S-30

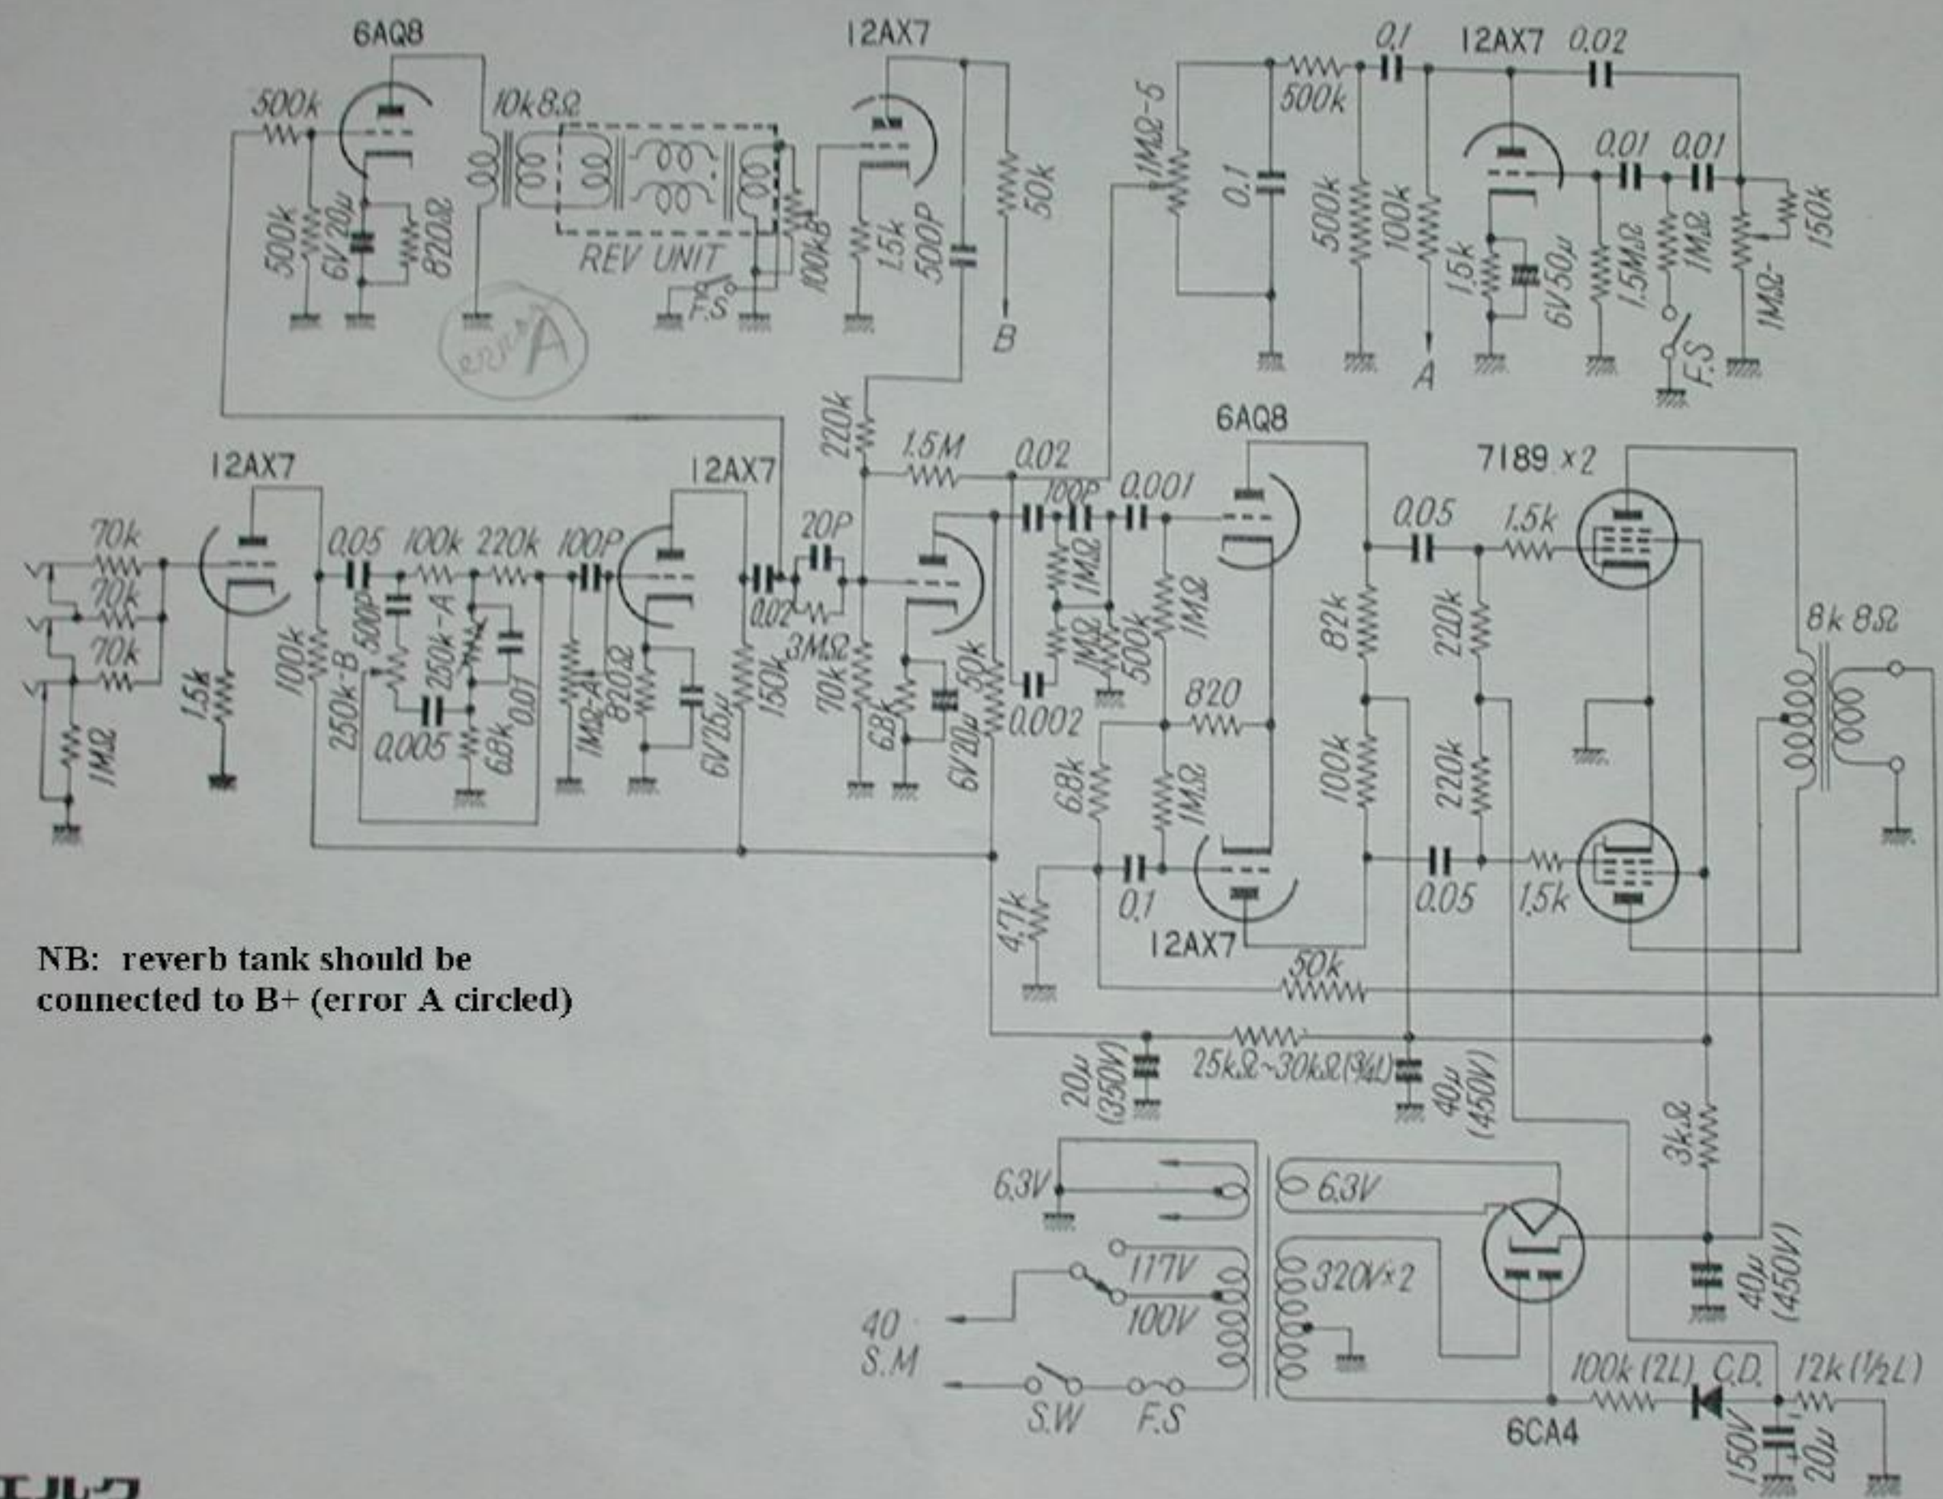
NB: reverb tank should be connected to B+ (error A circled)
